Subject: Re: Notes on Art House Hotel application **Attachments:** Hotel Lettering v2.pdf; 12 A3.1 HVAC Shed.pdf

I have a few notes on your application including minor changes and requests for additional information. These are just preliminary comments.

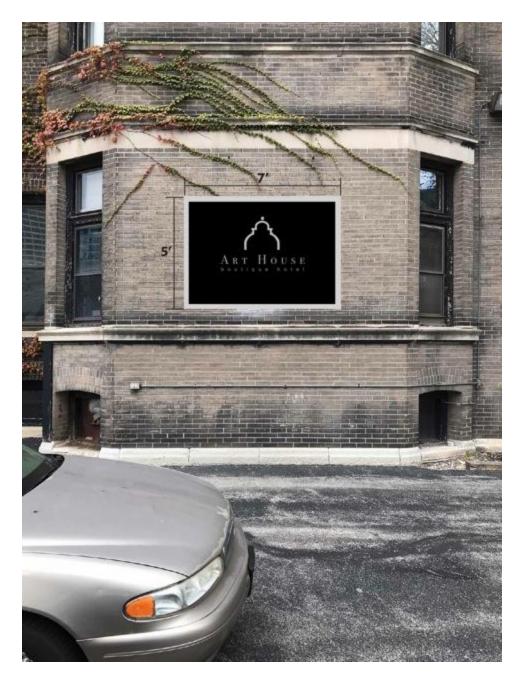
1. Fence

We designed the fence to be simple, textured, affordable and in-keeping with the building's era. I found images capturing concepts seen in our version, but no examples that replicate it.

Alt width, but includes cap and even top.

One of the many styles of cedar fences with post caps and alternating width pickets

Staggered top, a bit more "rustic" than our design and intent.

Fence: We have not traditionally approved shadowbox/board-on-board fences and fences must be painted or treated with opaque stain. See attached for other cedar plank fences that can be readily approved, but you are by no means limited to those designs.

The fence is NOT a shadow box design (as seen on p. 10 / 90 of your attachment and called "Board on Board"). It is same-side alternating 1x6 and 1x3 pickets, with minimal relief (<1") between pickets. Please advise if this changes your thoughts. We'd be happy to comply with paint or opaque stain.

Probably fine, can you find and provide a photo example?
